# SR 92 REALIGNMENT AND WIDENING

## Value Engineering Study Report

Preliminary Design Stage

May 2008

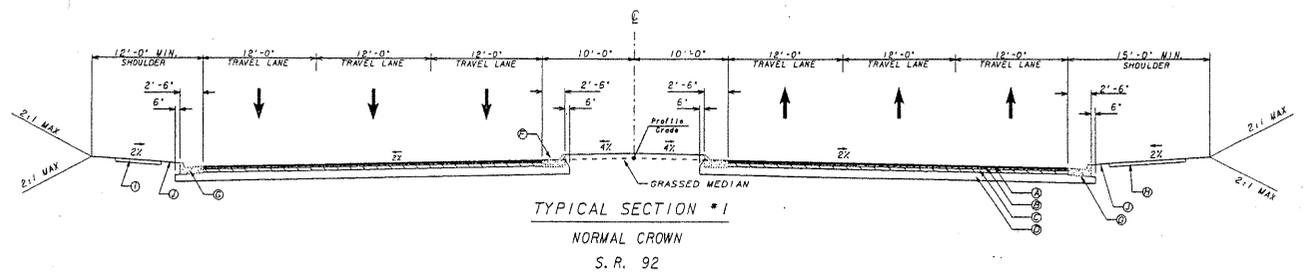
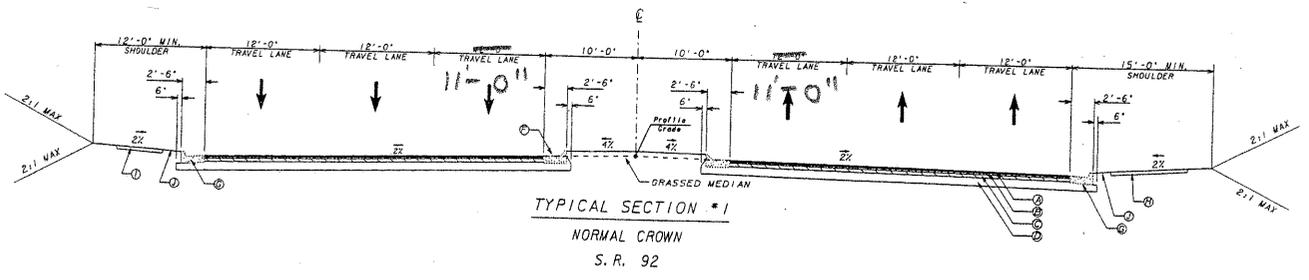
This alternative would save two ft. of pavement and right-of-way along the length of the project. As trucks favor the outer lanes, the lane width reduction impact is not as critical on the inside lane. The gutter spread issues for the inside lanes will only occur where the alignment curves. The inside lanes have an additional two ft. of gutter for vehicles to maneuver.

The design concept report classifies this road as an urban minor arterial. AASHTO guidelines state that 11-ft. lanes are allowable, but that 12-ft. lanes are most desirable and should be used on high speed, free flowing principal arterials. GDOT guidelines specify 12-ft. lanes. As lane widths are one of 13 FHWA controlling criteria, it appears a design exception is required.

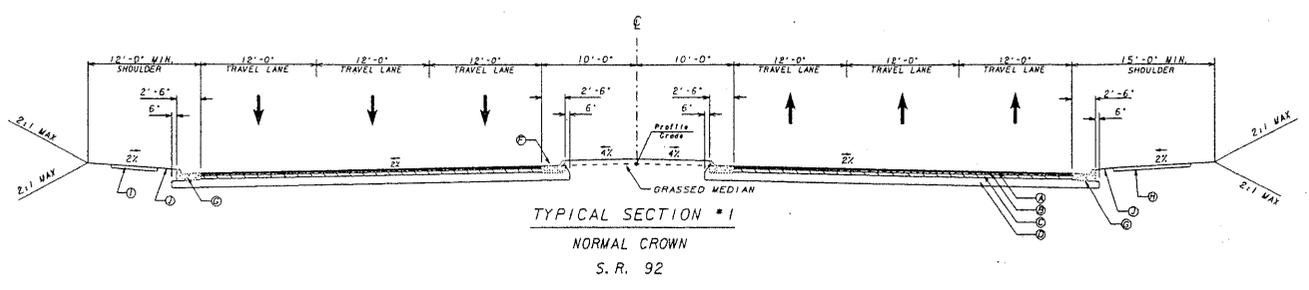
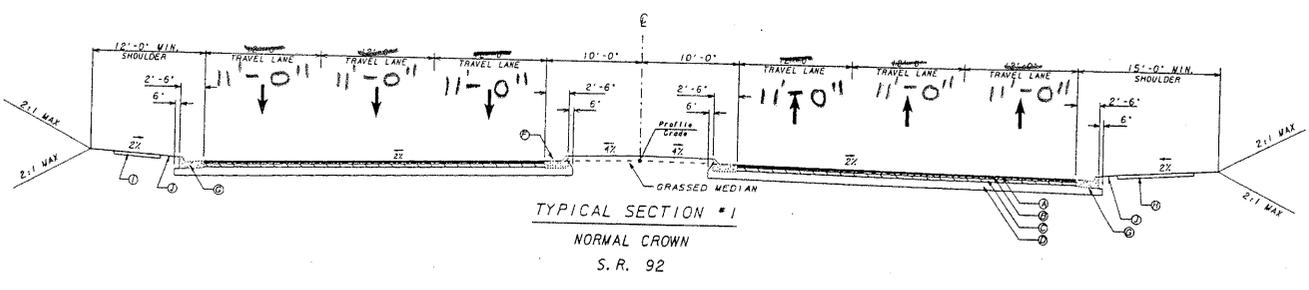
This alternative would save six ft. of pavement and right-of-way along the length of the project. The gutter spread issues for the inside lanes will only occur where the alignment curves.

The inside lanes and outside lanes have two ft. of additional room owing to the gutter width. The middle lane should have the most constrained situation for this alternative.

The design concept report classifies this road as an urban minor arterial. AASHTO guidelines state that 11-ft. lanes are allowable, but that 12-ft. lanes are most desirable and should be used on high speed, free flowing principal arterials. GDOT guidelines specify 12-ft. lanes. As lane widths are one of 13 FHWA controlling criteria, it appears a design exception is required.

ALTERNATIVE NO  
**TS-R-7**

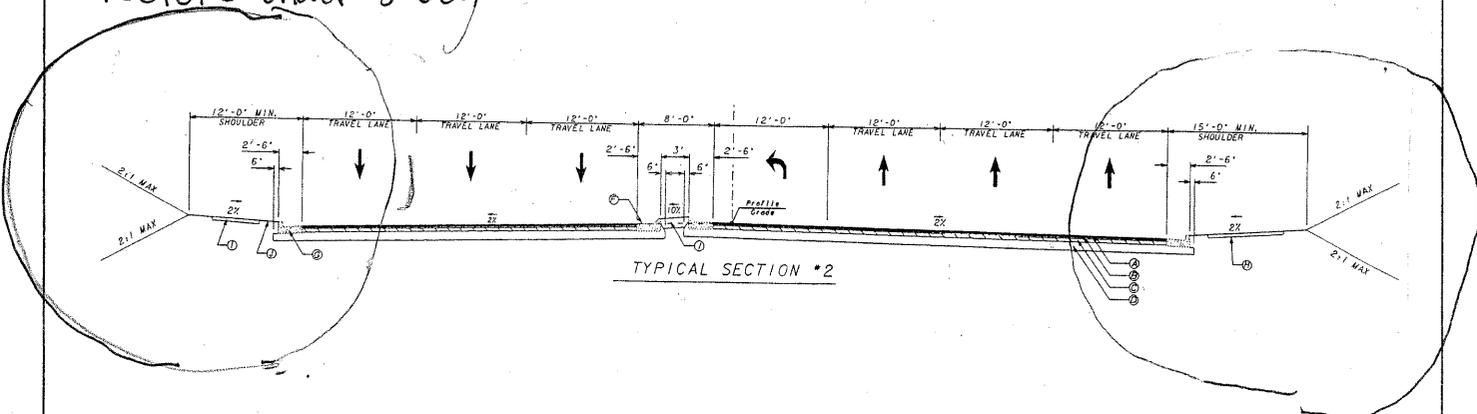
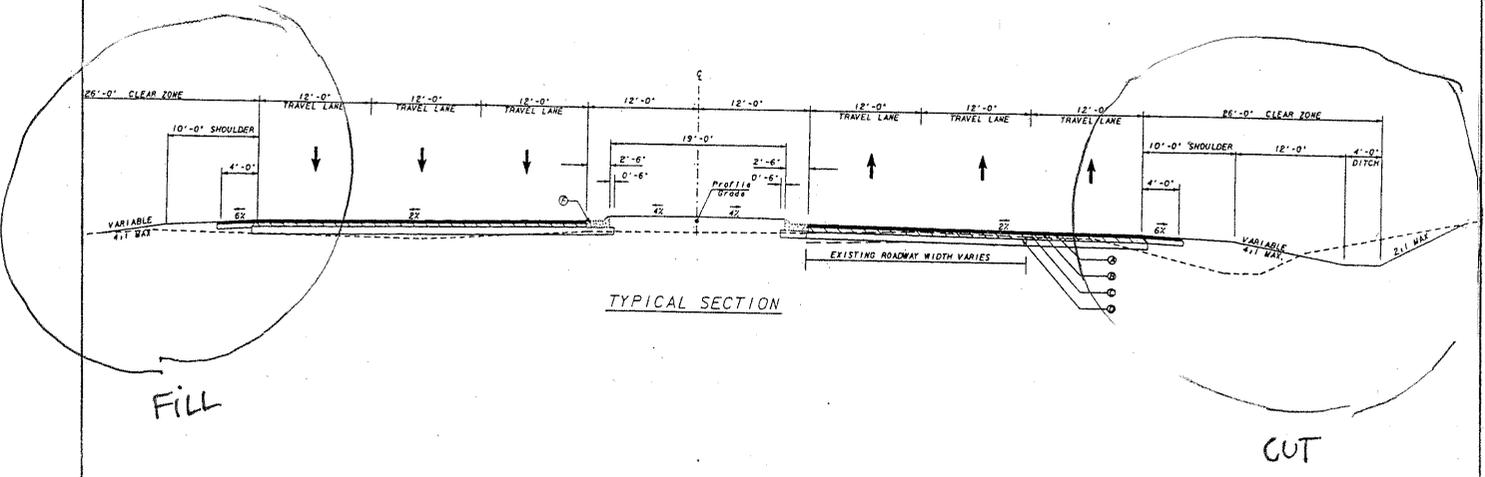
CURRENT DESIGN:  
URBAN SHLD

800 LF  
Add'l ROW take

Alternate (RURAL SHLD):

RESIDENTIAL DISPLACEMENT  
COMMERCIAL DISPLACEMENT  
ENVIRONMENTAL CONSTRAINTS  
1" = 200'  
EXISTING TRAFFIC SIGNAL  
ALT. # HA-R-1  
TRAFFIC SIGNAL

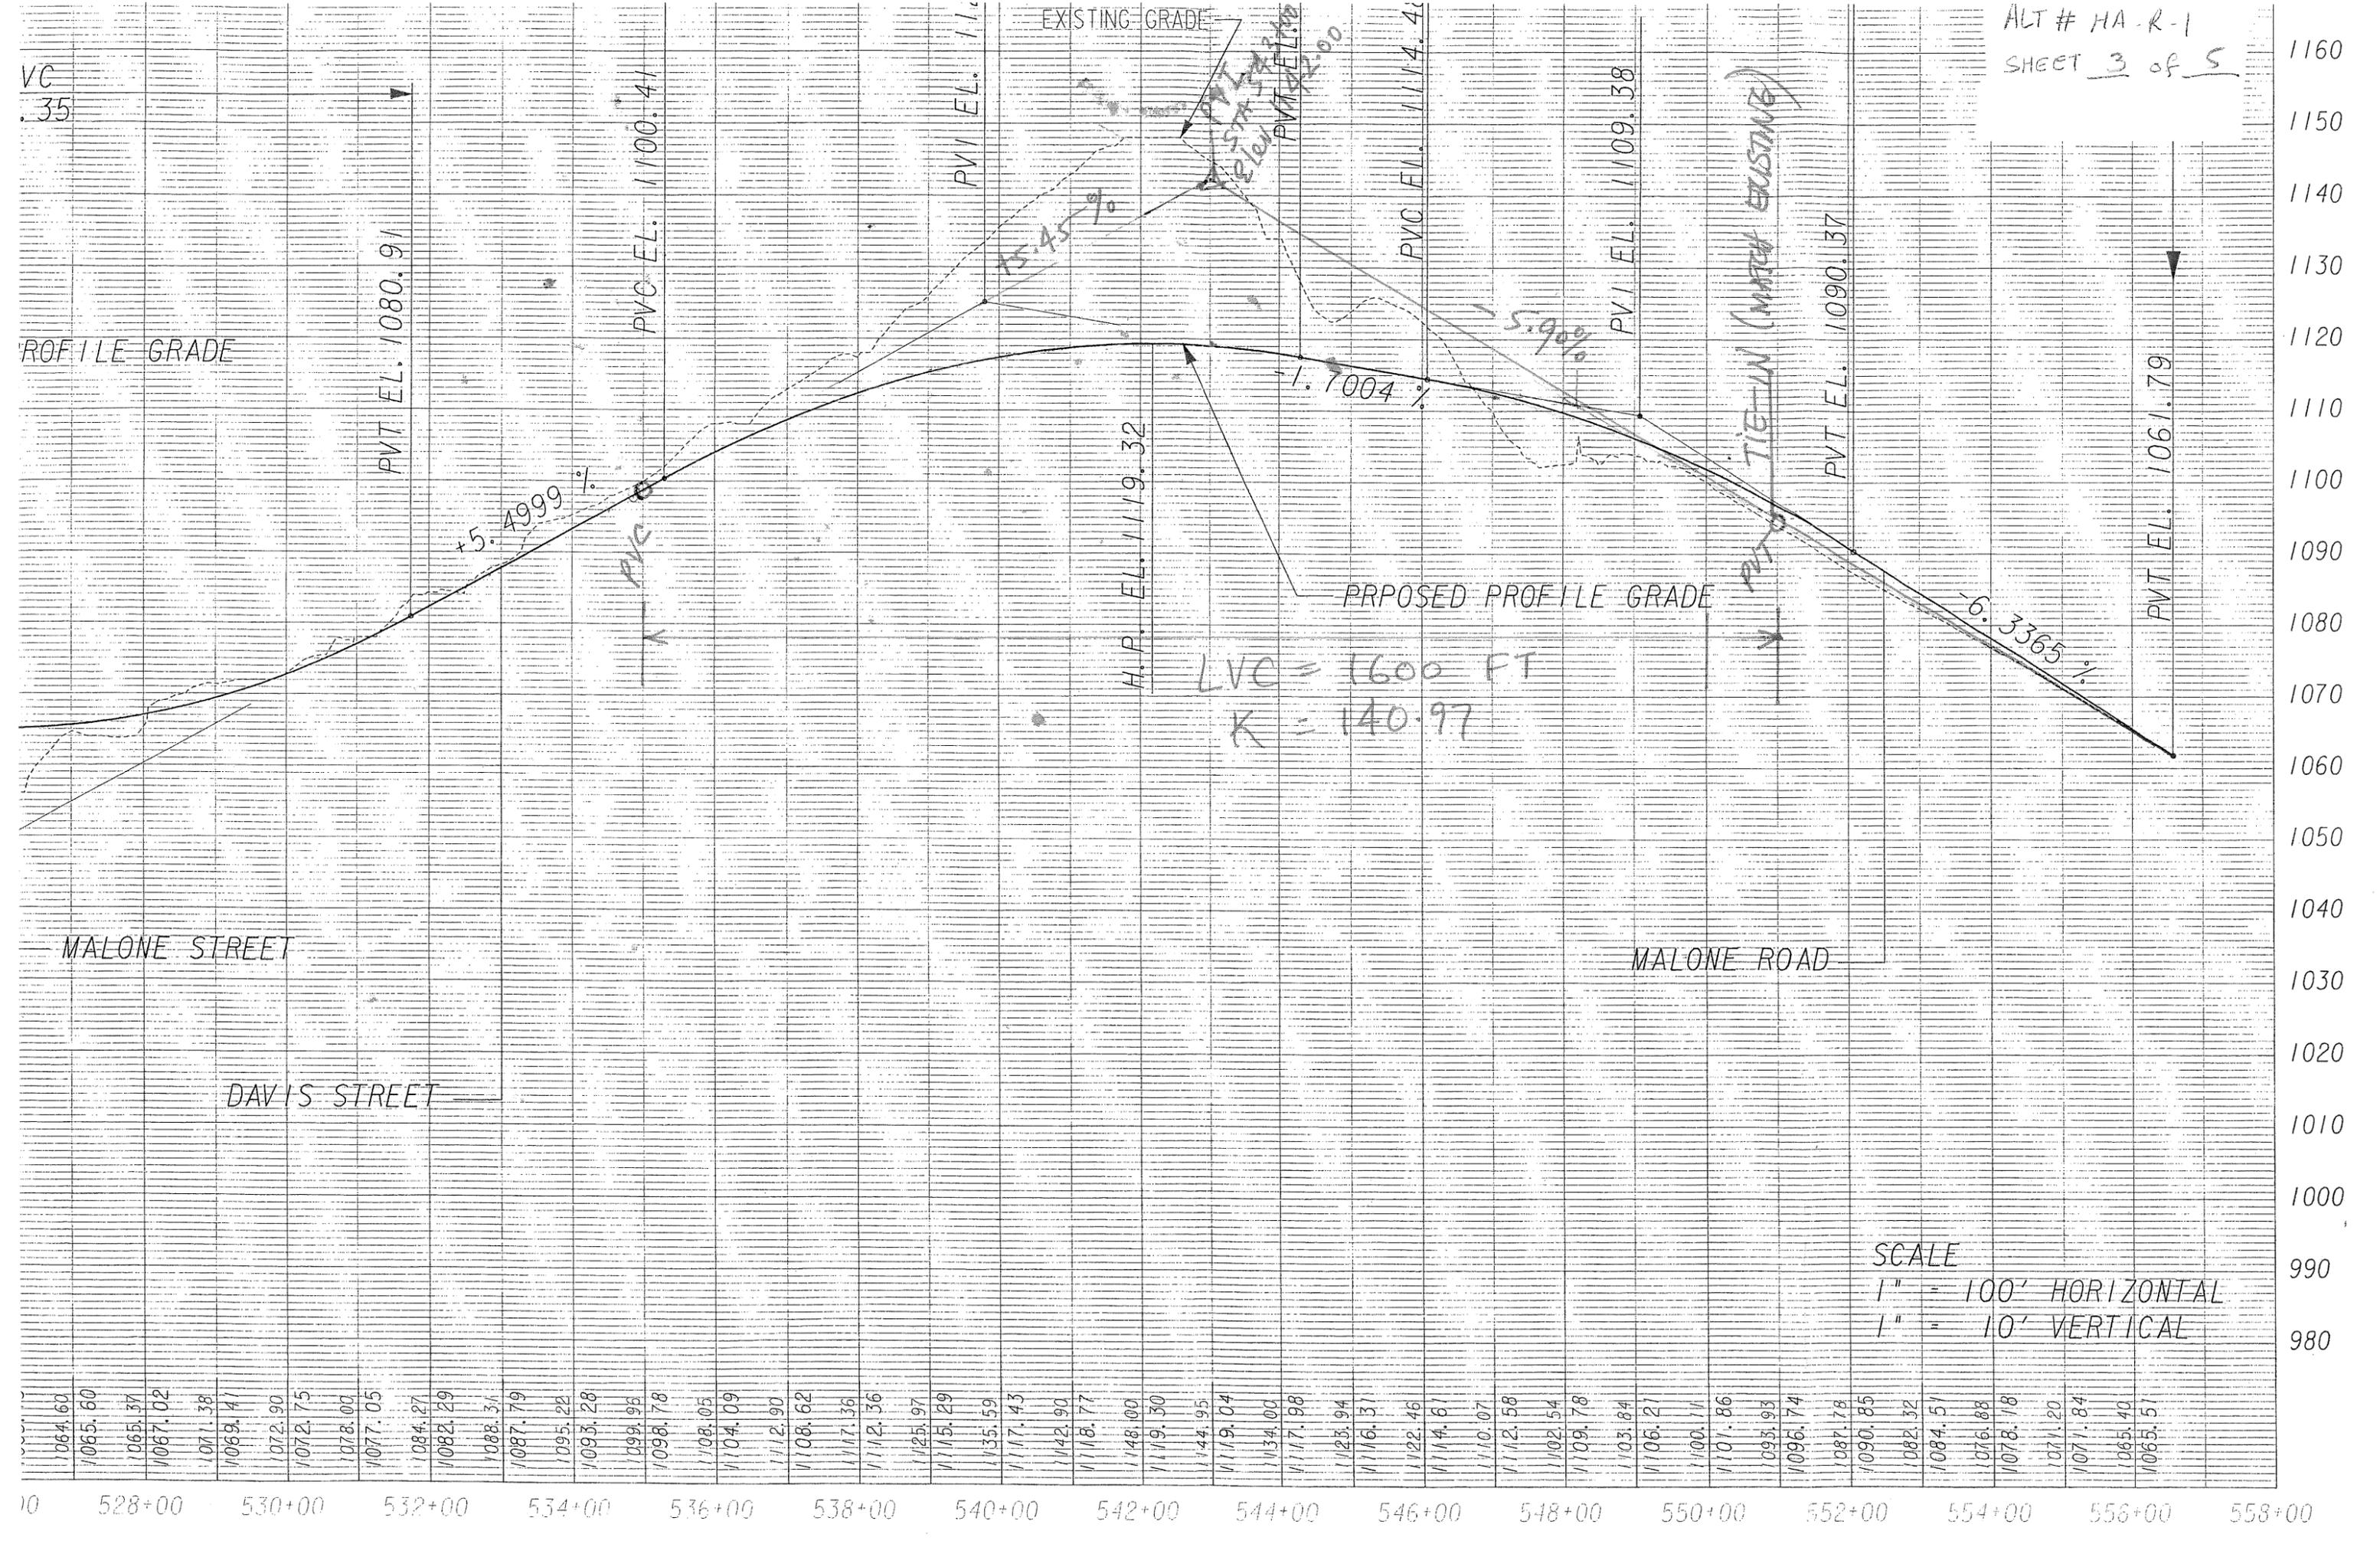
Eliminate the mainline S-curve with a single curve at  $R = 1,000$  ft. According to AASHTO Green Book (2004), the minimum radius curve required for the design speed of 45 MPH, for  $e = 4\%$  maximum, is 711 ft. The profile can be improved by combining two vertical curves into one at PVI 543+00, LVC = 1,600 ft. Revise Davis Street 90 degree bend further south.
